<div>McGRATH SUB-REGIONAL HEALTH CENTER</div> <div>COVER SHEET & INDEX</div>		FILE NAME:	
		PROJECT NO:	0198
		PROJ ARCH:	BK
DATE:	4/20/2009		
SCALE:	AS NOTED		
DRAWN BY:	CFP		
SHEET G-001			
1 OF 16

McGrath Health Clinic RFI #: 08
(PROJECT)
Hollow Metal submittal review June 30, 2010
REFERENCE: (DRAWING OR SPEC.) (DATE)

H.C. Toilet Room 102:

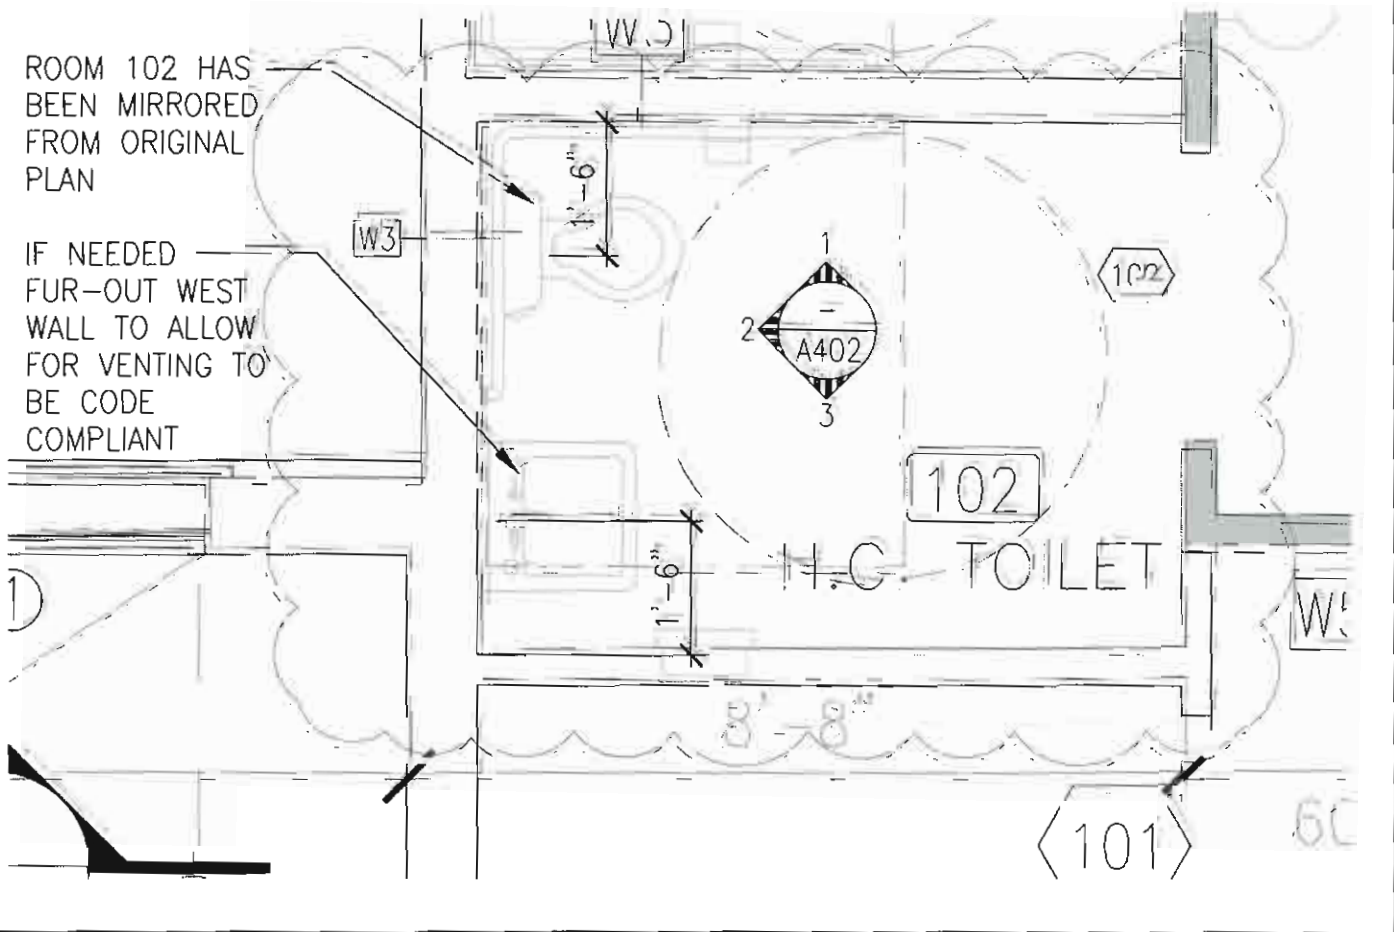
1. Drawing A-102 of the construction documents **ADD** two fire extinguishers with cabinets. One fire extinguisher and cabinet shall be mounted on the south wall of Waiting Room 104 two feet from the west wall. The second fire extinguisher and cabinet shall be mounted on the north wall of Waiting Room 127 five feet from the west wall. Fire extinguishers and Cabinets shall be provided and installed per Project Manual section 10520.

The room layout of room 102 shall be mirrored to resolve the toilet drain conflict as shown in the sketch below.

<p>McGRATH SUB-REGIONAL HEALTH CENTER</p> <p>FOUNDATION PLAN</p>		<p>FILE NAME: _____</p> <p>PROJECT NO: 0198</p> <p>PROJ ARCH: BK</p>
<p>DATE: 4/20/2009</p> <p>SCALE: AS NOTED</p> <p>DRAWN BY: MJD</p>

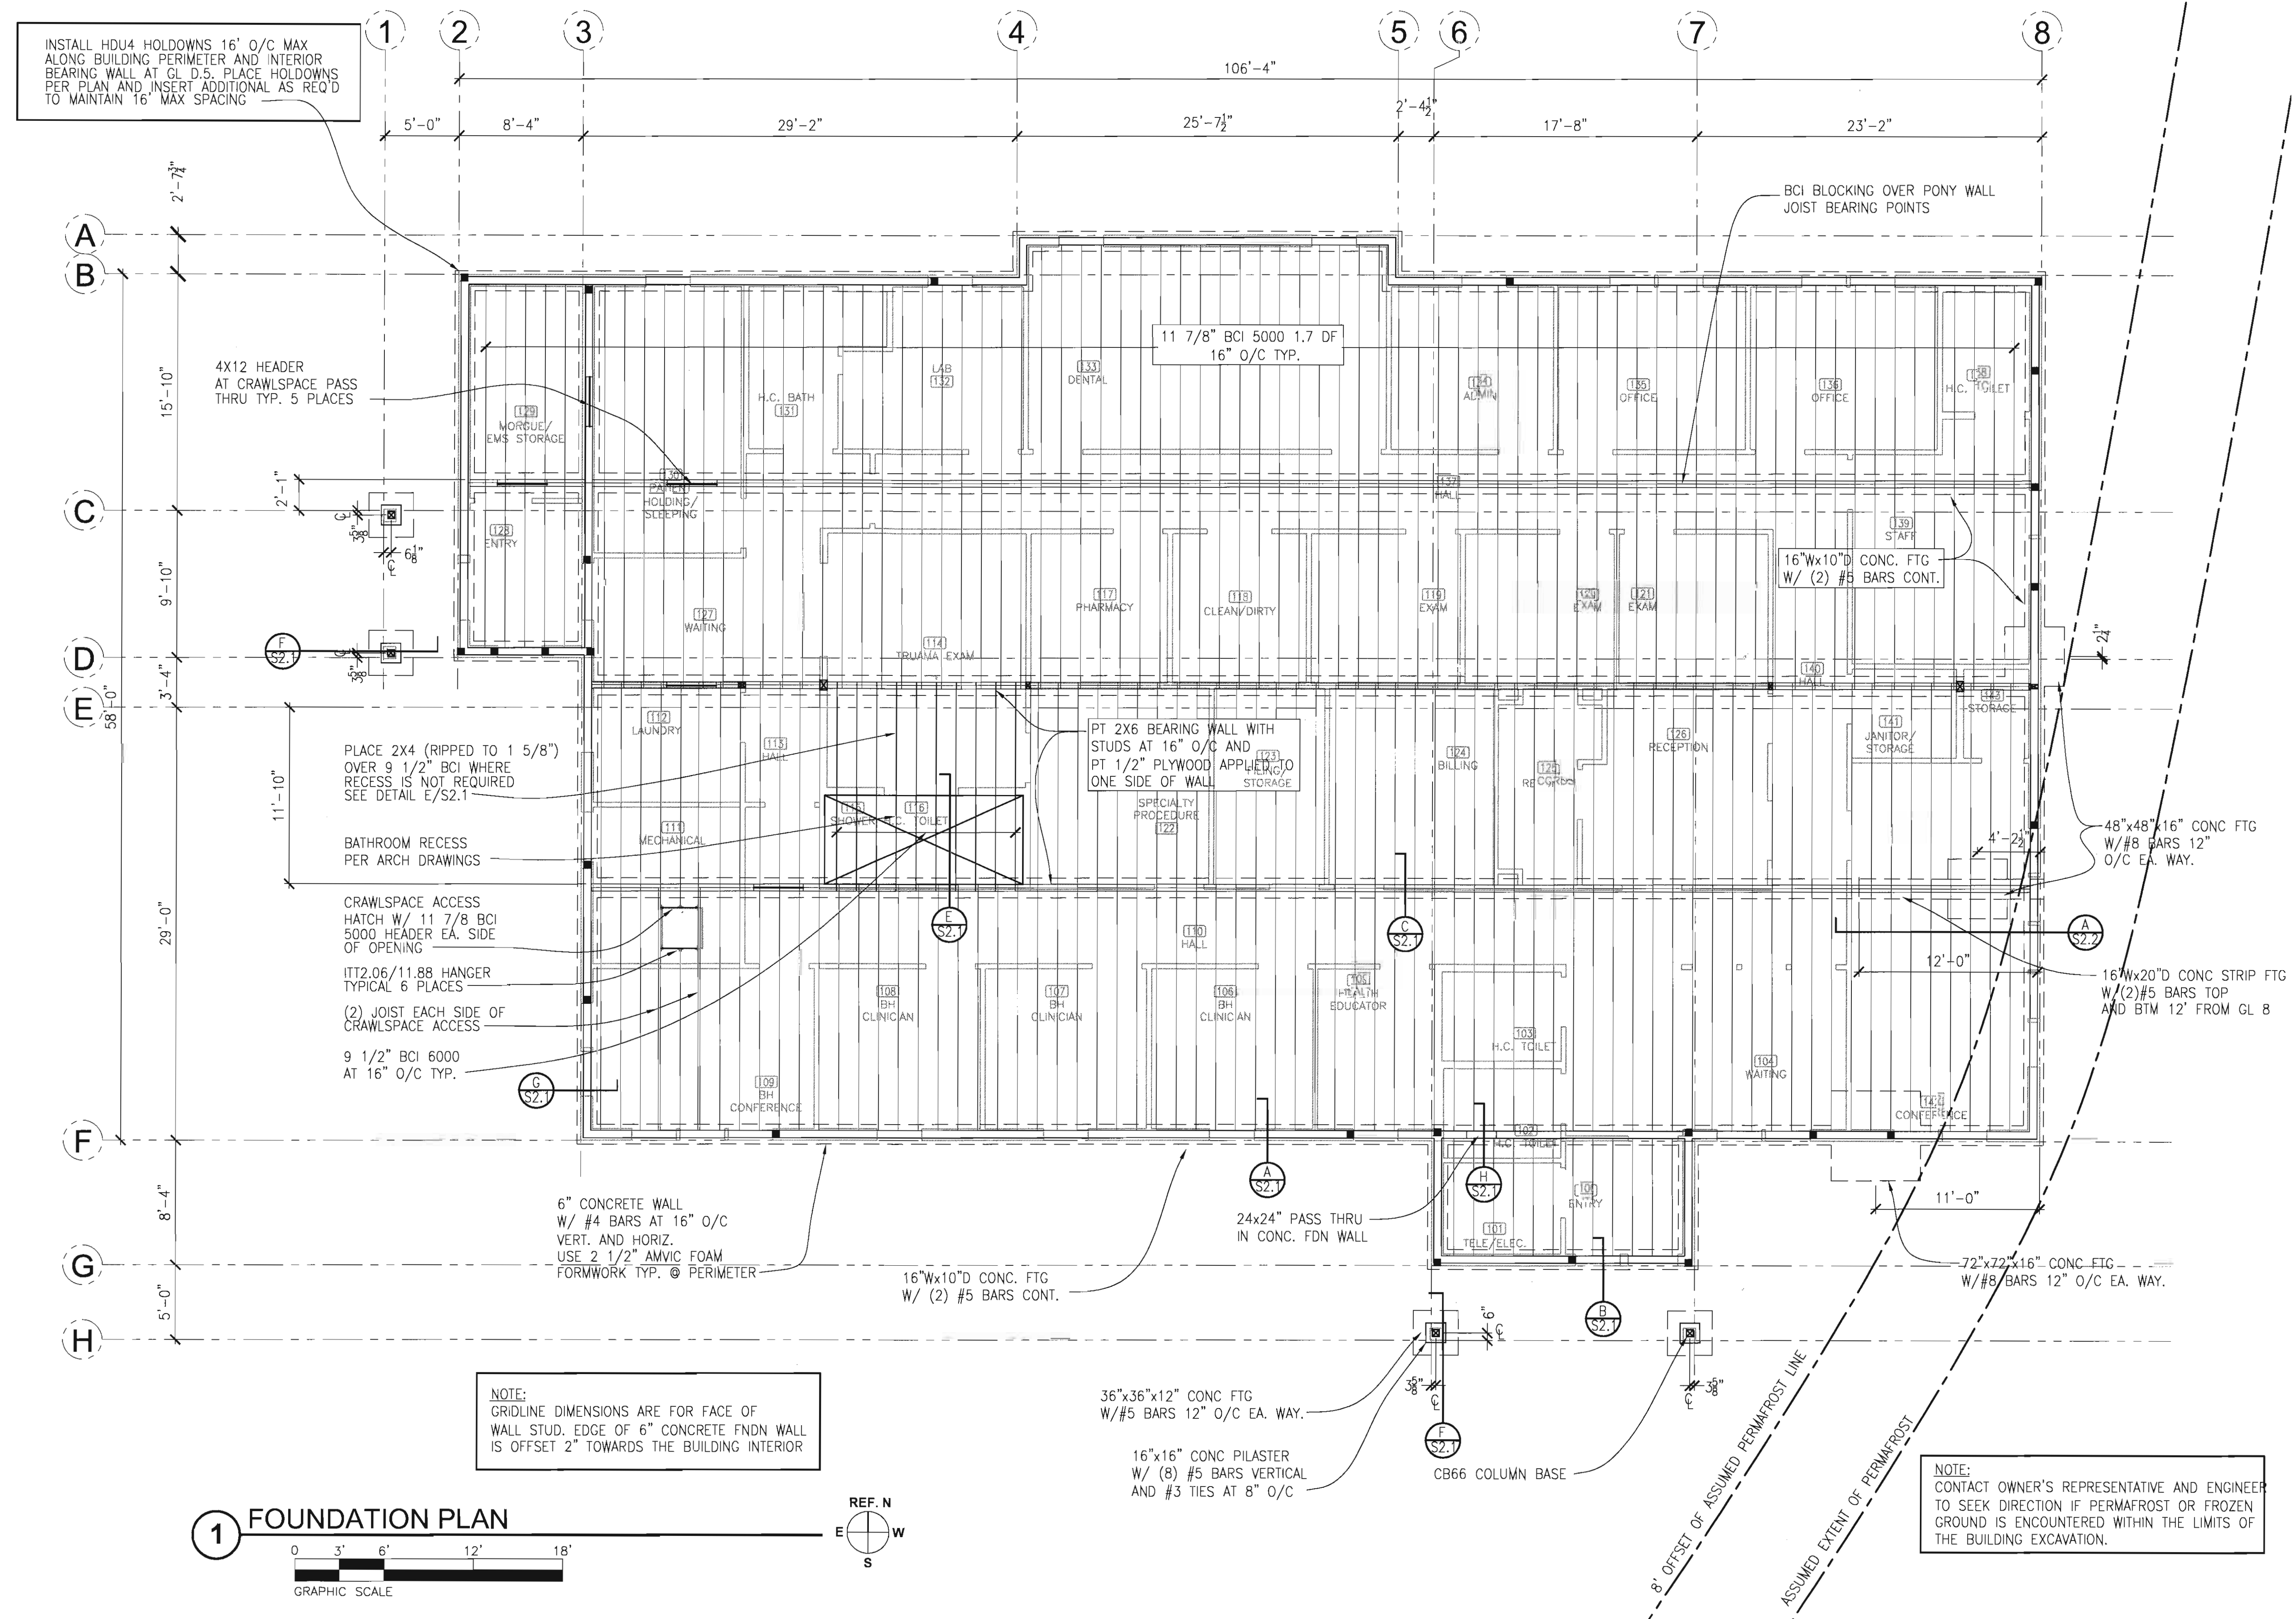
McGrath Health Clinic RFI #: 11
(PROJECT)
Detail F S 2.1 July 14, 2010
REFERENCE: (DRAWING OR SPEC.) (DATE)

DESCRIPTION: The footings for the 4 pilasters were poured at the wrong elevation and are the same as the building foundation instead of 5' below finish grade as per detail F on sheet S 2.1. Will this be acceptable with the addition of some insulation over the top of the footings? Please let me know asap please.

Greg Waisanen
(REQUESTED BY)
(DATE)
RESPONSE: 10/11
This results in an 18" difference in the elevation of the footing between design and installation.
Place 4" of rigid insulation over the top of the footing and 4' beyond the edge of the footing, at the top of footing elevation.

McGRATH SUB-REGIONAL HEALTH CENTER CRAWLSPACE PLUMBING PLAN	
FILE NAME: 08167-M11 LAYOUT NAME: LAYOUT1 SCALE: AS NOTED DRAWN BY: TCH	DATE: 04/20/09 SHEET: M1.1 3 OF 8M

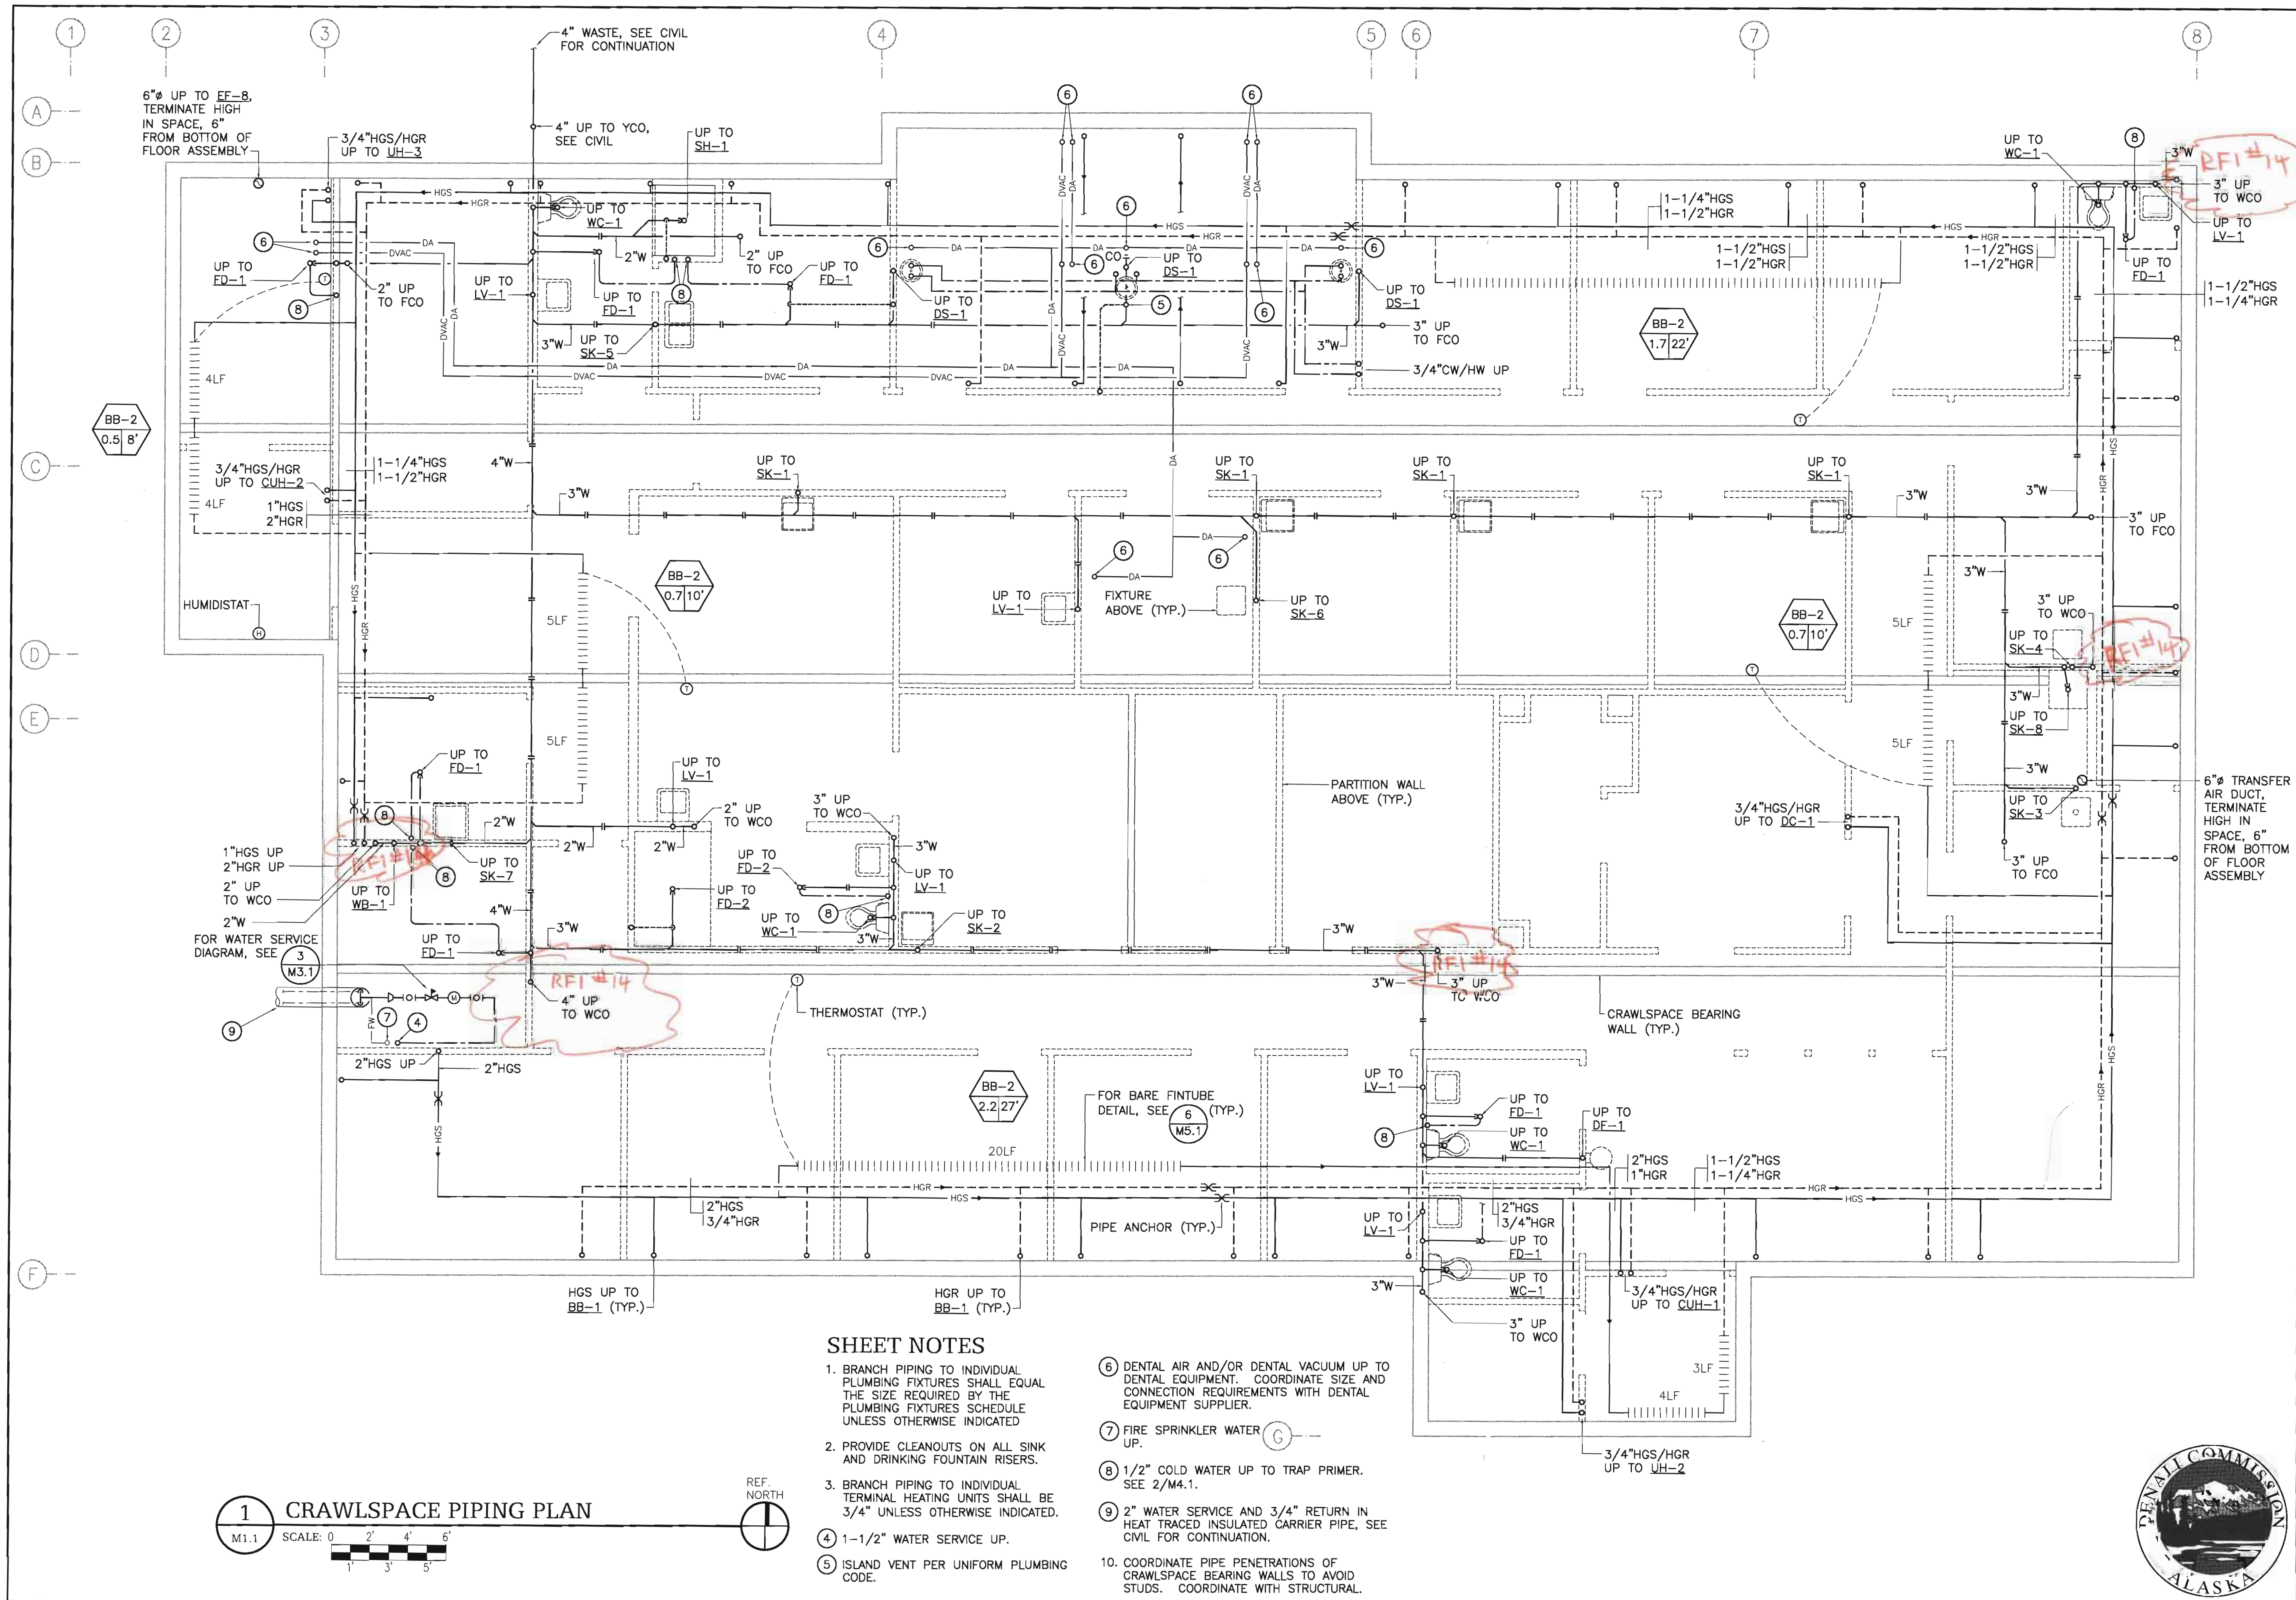
DESCRIPTION: Sheet M1.1 shows both floor and wall clean outs. Some of the wall clean outs are shown in 2 x 4 walls which will not allow enough room. Can we option 1 locate all clean outs in the crawl space or option 2 change to all floor clean outs?
